RE: Safety Recall 07V-084

Coachmen RV Company has decided that a defect which relates to motor vehicle safety exists in 2007 Capri Micro Travel Trailers, model 135 RE. These vehicles were manufactured at Coachmen RV's Middlebury, Indiana facility from November 28, 2006 through January 5, 2007.

## Engineering Service Procedure

**Title:** LP Tray Bolt Replacement

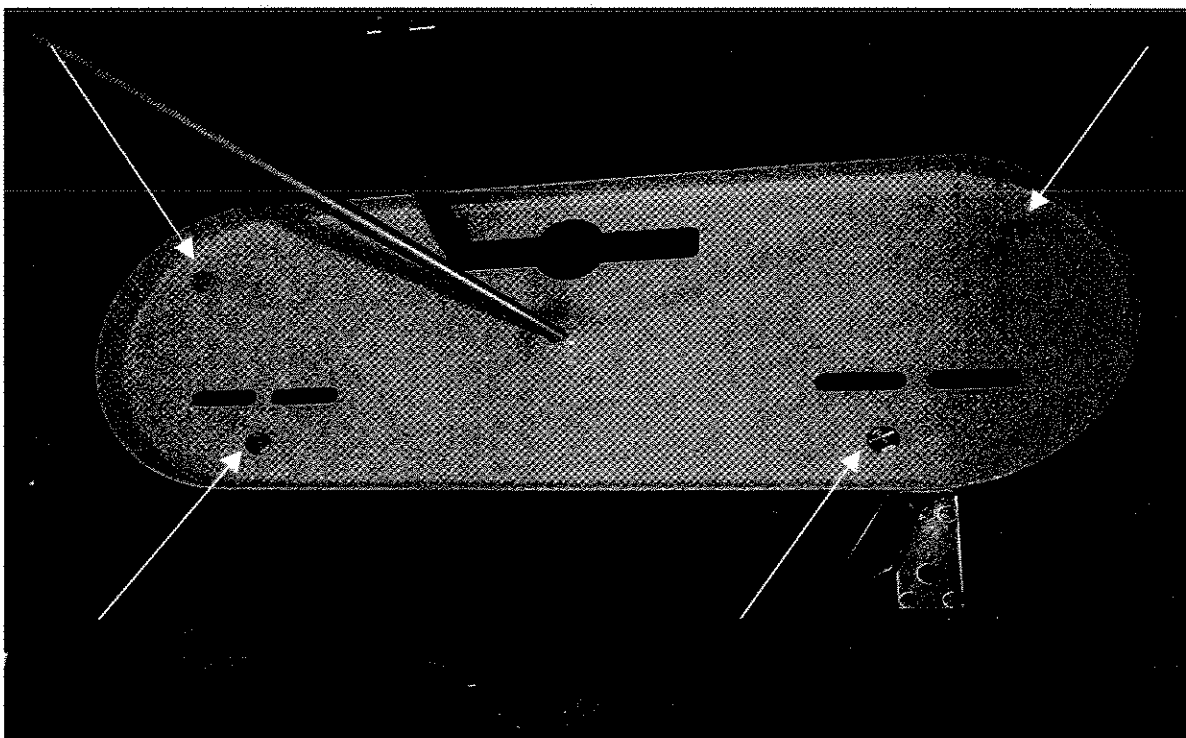
On affected vehicles, the self tapping screws that are used to secure the LP Bottle support tray to the trailer frame may fail. The support tray is mounted to the A frame of the trailer and holds the LP bottles securely in place. Should these screws fail, the LP bottles could come loose, disengage from the trailer and cause an accident. The potential for failure will depend on road surface conditions. If significant contact were to occur over a period of time, the LP tank or lines could be damaged and potentially leak LP gas, which could result in a fire.

1. Loosen the LP tank hold down wing nut on the top of the LP bottles.
2. Unscrew the LP hoses from both tanks and remove tanks from the tray.
3. Using a 1/2" wrench, remove the four bolts that secure the tray to the frame.
4. Install the four replacement 5/16" x 18 x 1-1/4" bolts in the existing frame holes. **DO NOT OVERTIGHTEN.** Torque bolts to only 15 ft.-lb.
5. Place bottles back on tray and secure with hold down wing nut.
6. Attach LP hoses to LP bottles.
